Access Compliance Report

Public Rights-of-Way

Intersection ID: 30054	Main Street: DAY_LILLY_LN	Cross Street: SOUTHWIND_DR	Location: NE
ADA ID: AE6237956819	Ramp Type: PerpDiag	Initial Pass/Fail: Fail	Overall Compliance: No
		Severity Score: 25

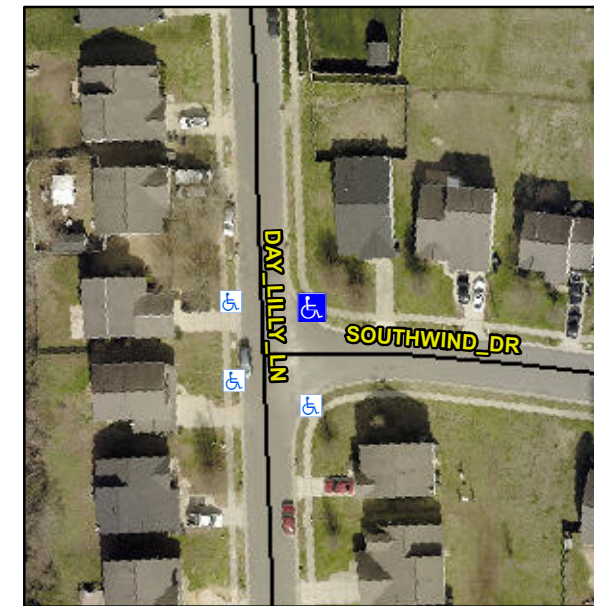
R304.2.2, R304.5.3

Compliance	Description	Data	Compliance	Description	Data
N/A	Ramp Length (in)	47.0	No	Ramp Slope (%)	11.2
Yes	Ramp Width (in)	48.0	No	Ramp XSlope (%)	5.4
N/A	Flare Type LT	N/A	N/A	Flare Type RT	N/A
N/A	Flare Slope LT (%)	N/A	N/A	Flare Slope RT (%)	N/A
N/A	Flare Traversable LT?	N/A	N/A	Flare Traversable RT?	N/A
N/A	Landing Length (in)	N/A	N/A	DWS Provided?	N/A
N/A	Landing Width (in)	N/A	N/A	DWS Contrast?	N/A
N/A	Landing Slope (%)	N/A	N/A	DWS Length (in)	N/A
N/A	Landing X Slope (%)	N/A	N/A	DWS Full Width?	N/A
N/A	Landing Curb? (Y/N)	N/A	N/A	DWS Offset (in)	N/A
N/A	Shared Landing?	N/A			
N/A	Gutter Ponding?	N/A	N/A	Gutter Slope (%)	N/A
N/A	Gutter Lip Ht (in)	1.0	N/A	Gutter X Slope (%)	N/A
N/A	Painted X Walk1?	No	N/A	Painted X Walk2?	No
	X Walk 1 Direction	To W		X Walk 2 Direction	To S
N/A	X Walk 1 Width (in)	N/A	N/A	X Walk 2 Width (in)	N/A
	X Walk 1 Slope (%)	1.4		X Walk 2 Slope (%)	0.2
	X Walk 1 X Slope (%)	0.6		X Walk 2 X Slope (%)	1.5

Remove & Replace Curb Ramp With Two New Directional Ramps or Equivalent.
